POWER PLANT - ENGINE - POWERPLANT - FANCASE RAFT AND BRACKET - REPLACEMENT OF -
CATEGORY CODE 6 - MOD.ENG-71-0104

V2500-ENG-71-0104

Installation of raft and bracket
Fig.1

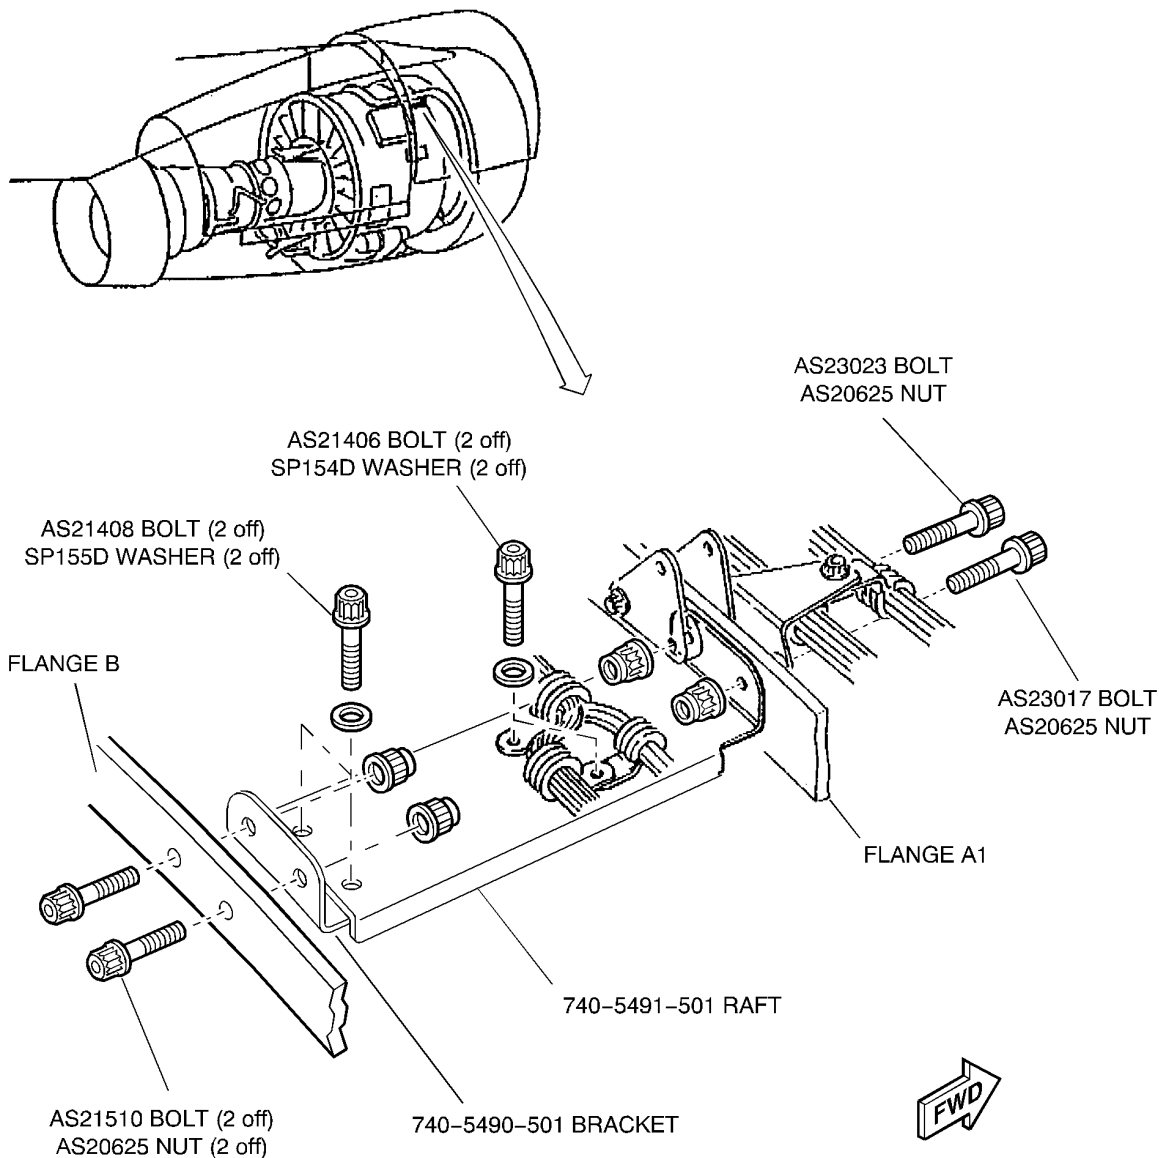
Insufficient clearance may exist between a bolt and the engine fancase at engine flange A1.

- (a) The raft and bracket that support the clipping points GP0810 and CP0811 are removed and replaced with a new raft and bracket.

- (1) Install the new raft and bracket by the approved procedures in reference 1.K.(1).
